ITEM FOR ENVIRONMENTAL BOARD AGENDA

**NAME & NUMBER
OF PROJECT:** EMBARCADERO
SP-06-0665D

MEMORANDUM

SUBJECT: Embarcadero (SP-06-0665D)
River Hills Road

WASTEWATER TREATMENT PLANT
IRRIGATION FIELDS
AND CEF SETBACKS EXHIBIT

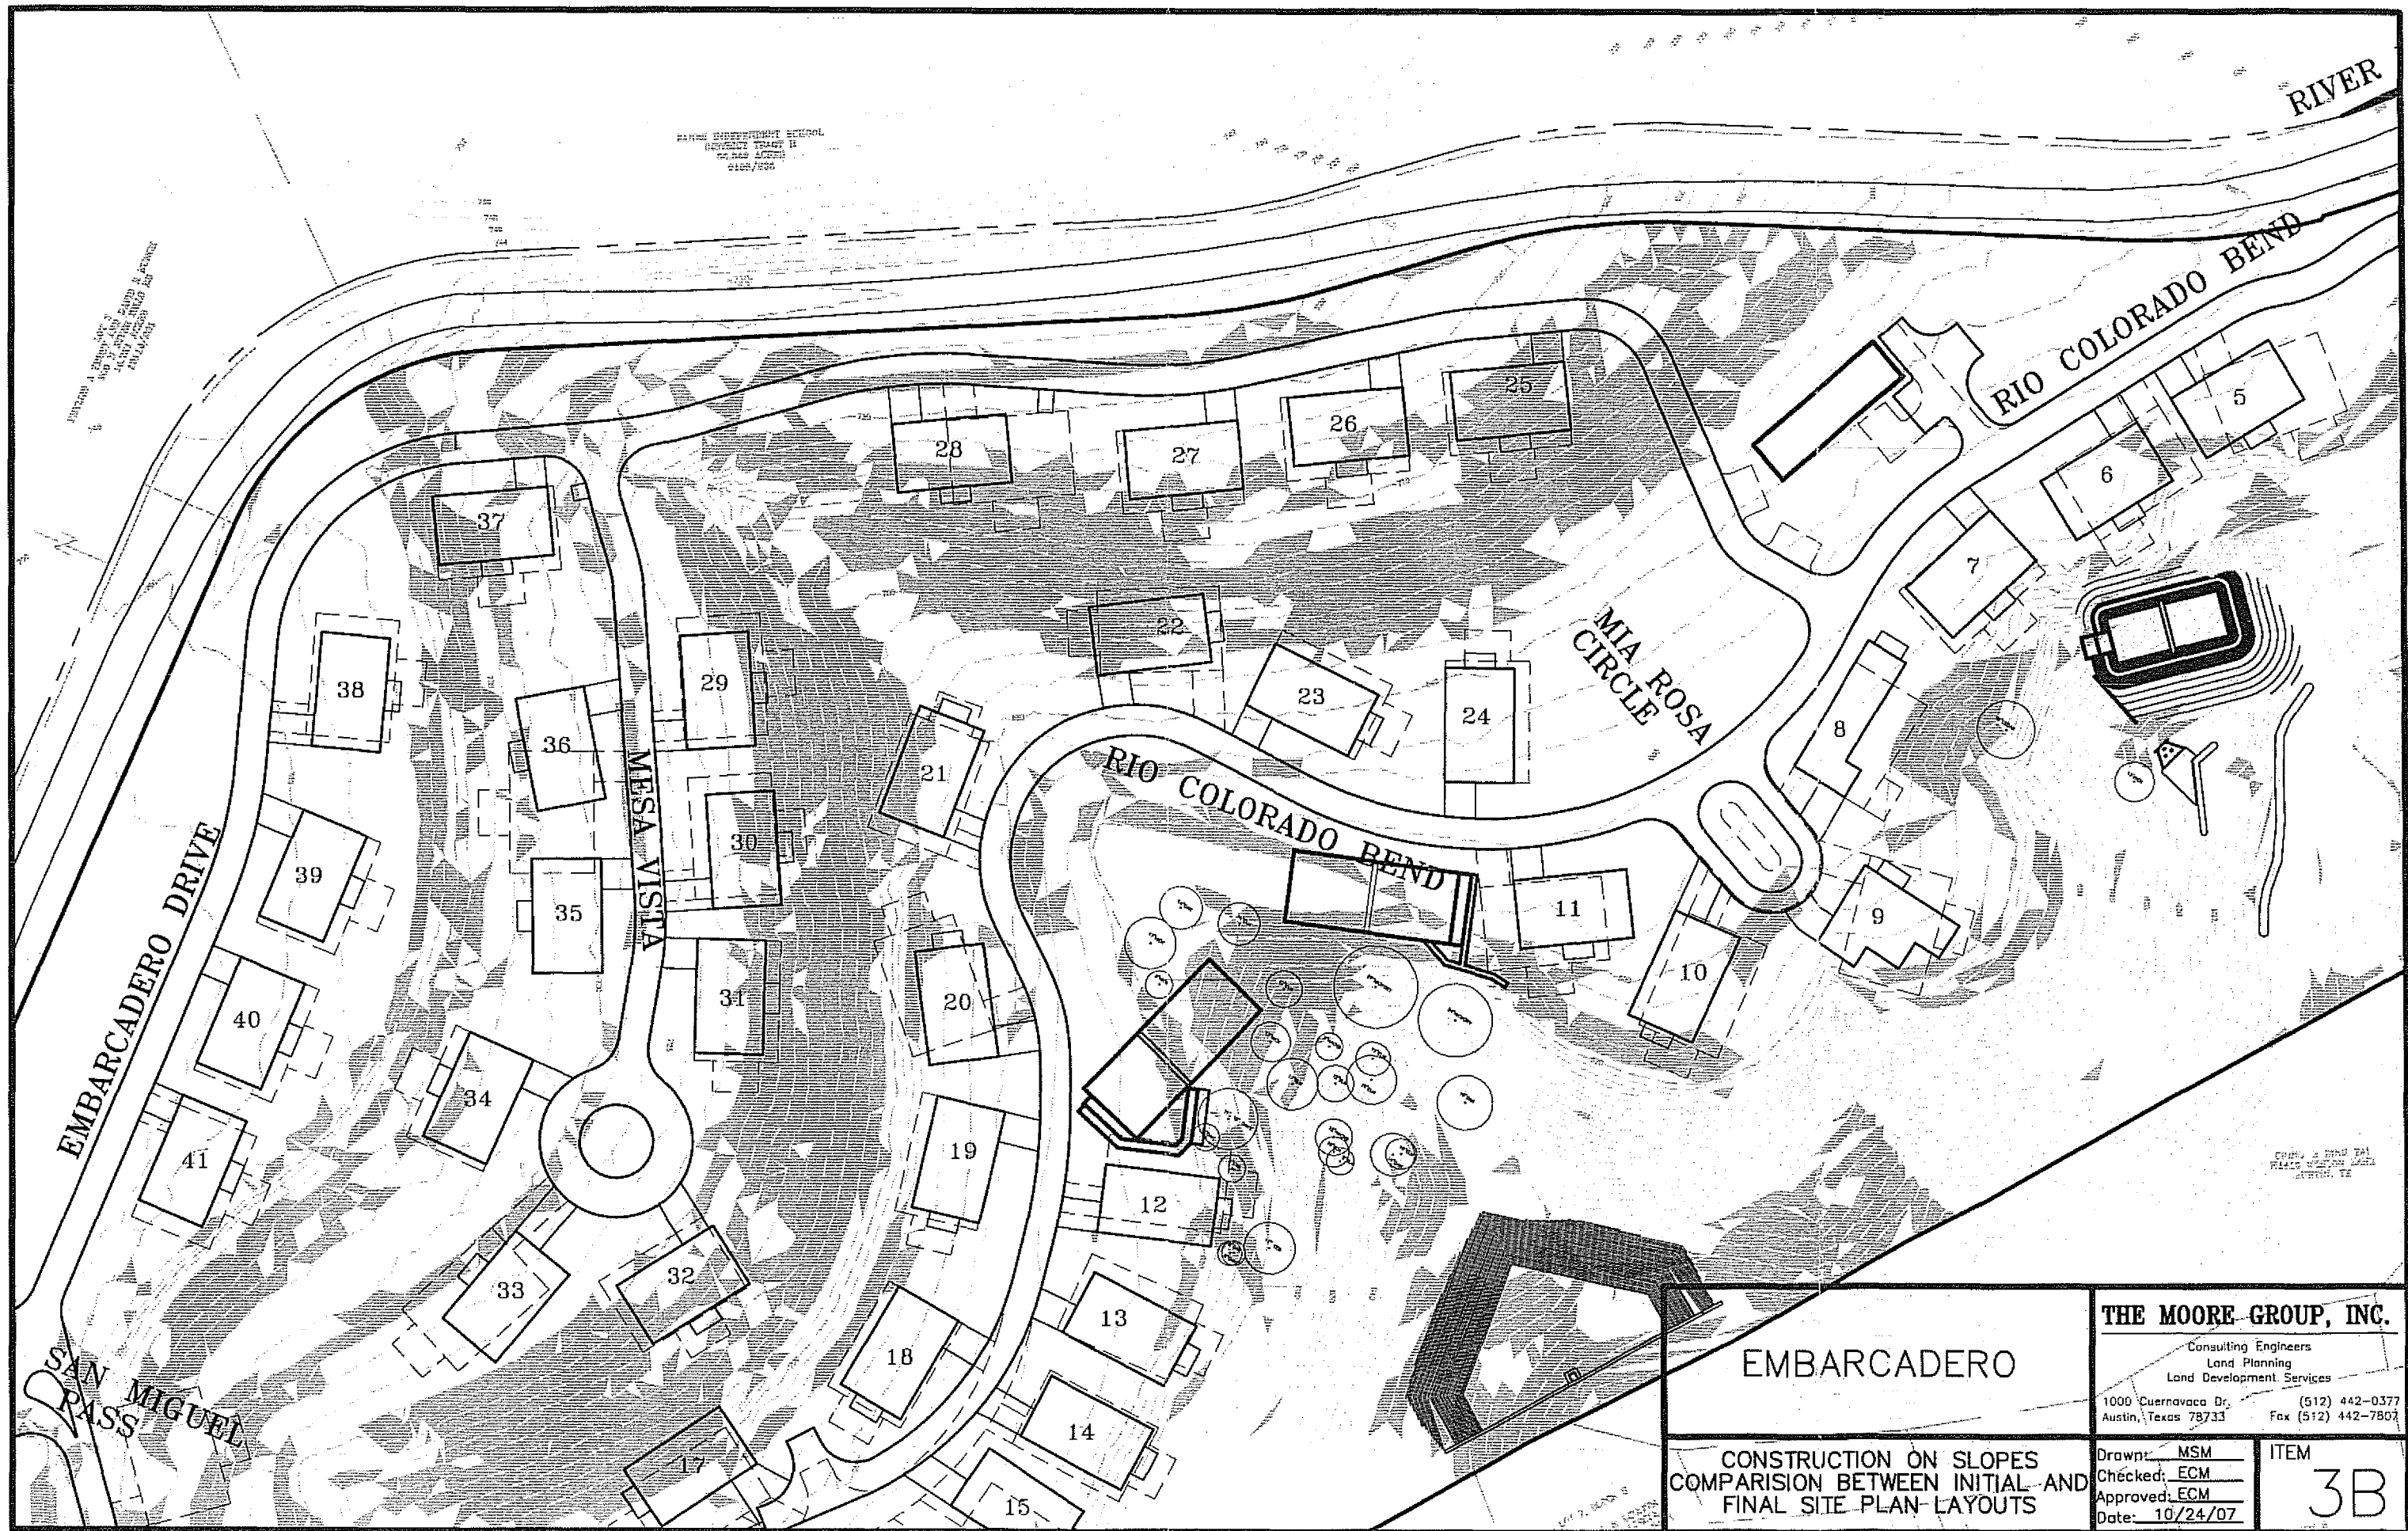
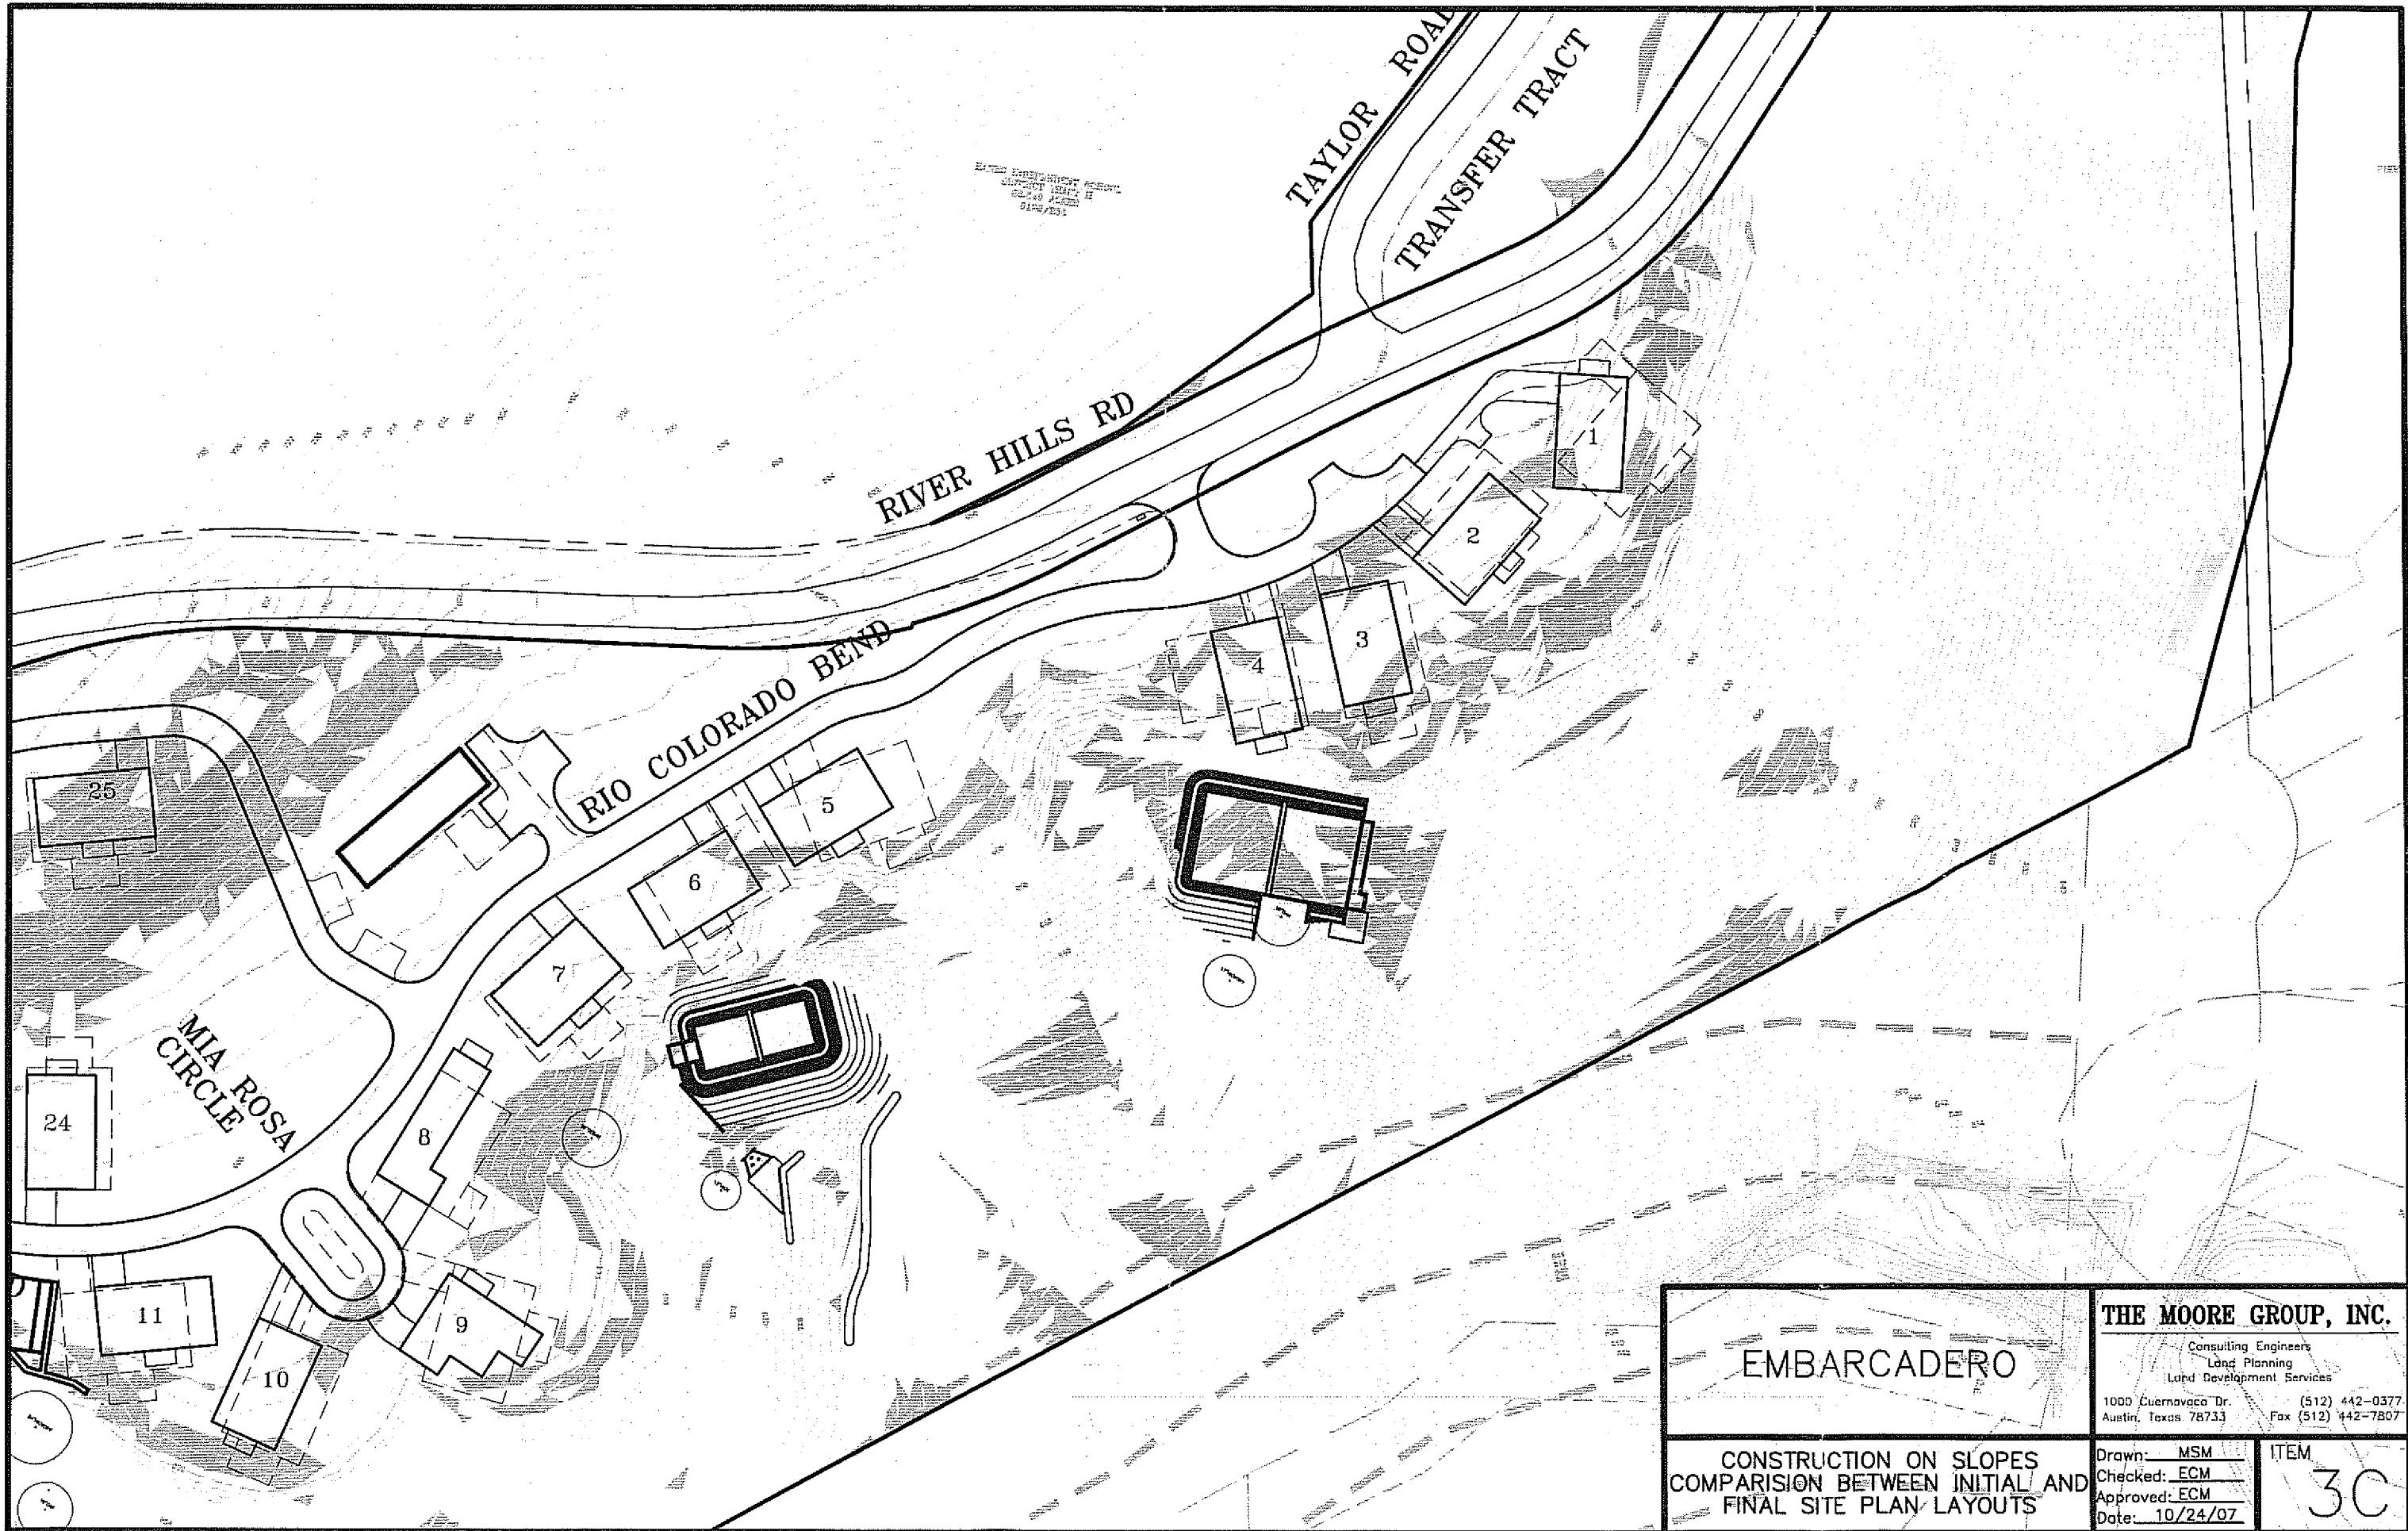
As stated above, the majority of the site consists of stair-step topography typical of the Hill Country, where bands of steeper slopes separate terraced areas. These terraced areas are flatter and have deeper soil profiles, and are typically the most desirable locations to develop. The applicant proposes to use some of these flatter areas as irrigation fields for an on-site wastewater system since the land is located at the upper end of a sensitive watershed. These flatter areas have a much deeper soil profile necessary for complete wastewater absorption, which in turn provides superior water quality protection than irrigating wastewater in areas with steeper slopes and little to no soils.

The applicant has proposed an on-site wastewater disposal system which treats the effluent twice before it is pumped to the irrigation fields. According to the attached COA Permit Application Review Committee's August 17, 2007 Memorandum, the State requires treatment to the following standards: 20 mg/L BOD5, 20 mg/L TSS for these type on-site wastewater systems. By providing a "Secondary Treatment", the applicant proposes to exceed these standards [Proposed system will meet: 10 mg/L BOD5, 15 mg/L TSS, 3 mg/L NH3-N, and 4 mg/L DO]. In addition, this wastewater system continuously monitors conditions in the wastewater irrigation fields and constantly makes adjustments to the system so the effluent is always discharged at the appropriate dosing rate. This type of wastewater system helps ensure 100 percent of the effluent can be assimilated into the soil matrix and plant tissue. The wastewater system will discharge the secondary effluent to six separate irrigation fields, totaling 3.73 acres (or 162,479 square feet, or 7.2% gross site area/12.20% net site area).

This variance is requested because of the applicants propose an advanced wastewater disposal system. The applicant's on-site wastewater disposal system is a state of the art computer monitored system that maximizes the systems efficiency and environmental protection while requiring less square footage for effluent disposal per LUE.
